Contract #: 04-0120F4Cty: SF/ALA Rte: 80 PM: 13.2/13.9File #: xx.25B**QUALITY ASSURANCE -- NON-CONFORMANCE REPORT****Location:** Changxing Island, Shanghai, China**Report No:** NCR-000898**Prime Contractor:** American Bridge/Fluor Enterprises, a JV**Date:** 23-Nov-2010**Submitting Contractor:** Zhenhua Port Machinery Company, Ltd (ZPMC), Changxing Island**NCR #:** ZPMC-0860**Type of problem:**

Reference Description: New Weld Procedure Requirements for New Welds Not Followed (Rager/McQuaid)**Description of Non-Conformance:**

Job Name: SAS Superstructure
Document No: 05.03.06-000855

Subject: NCR No. ZPMC-0860

The weld is identified as SEG3020AX-004.

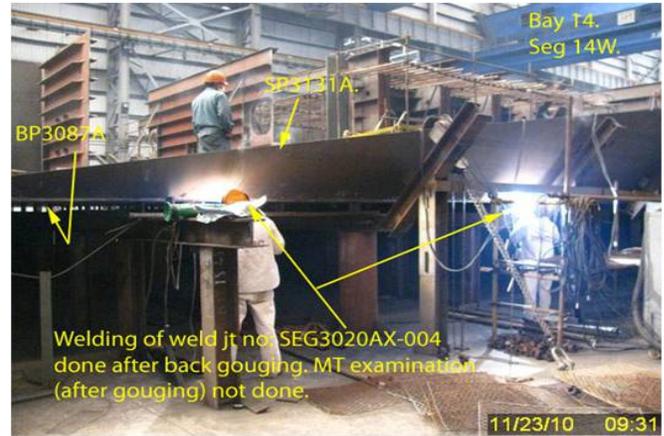
During Caltrans QA in process observations of the fabrication of OBG Seg 14W, this QA discovered the following issue: ZPMC welding personnel did not appear to be following the NEW WELD PROCEDURE (Rager/McQuaid). The following requirement was not followed:

6. Non Destructive testing (6A)

The weld is a CJP joining SP3131A to BP3087A.

Reference the attached pictures below.

A. All back gouged groove welds are to have their gouged areas ground to bright metal and inspected 100% by VT and MT examination before welding may begin from the second side.

The "NEW WELD PROCEDURE (Rager/McQuaid)" quoted as the basis for this NCR is not a contact document only a recommendation from the QA/QC Committee. If the Department wants to incorporate the QA/QC committee's recommendations as a contract requirement a contract change order should be issued. As this NCR was written without basis it should be withdrawn.

CT acknowledges contractor's response. However, successful NDT will close this NCR.

Normal NCR closure package with NDT reports shall be submitted with the NPR to close out the NCR.

Reference Resolution: ZPMC is providing acceptable NDT of the weld referenced in the NCR and requests closure of this NCR.
ZPMC is providing acceptable NDT of the weld referenced in the NCR and requests closure of this NCR.

This proposed resolution is acceptable. The documentation received is sufficient and the Department concurs that Non-Conformance ZPMC-0860 is closed.

Contractor provided the NDT report. The NDT report shows the weld is acceptable.
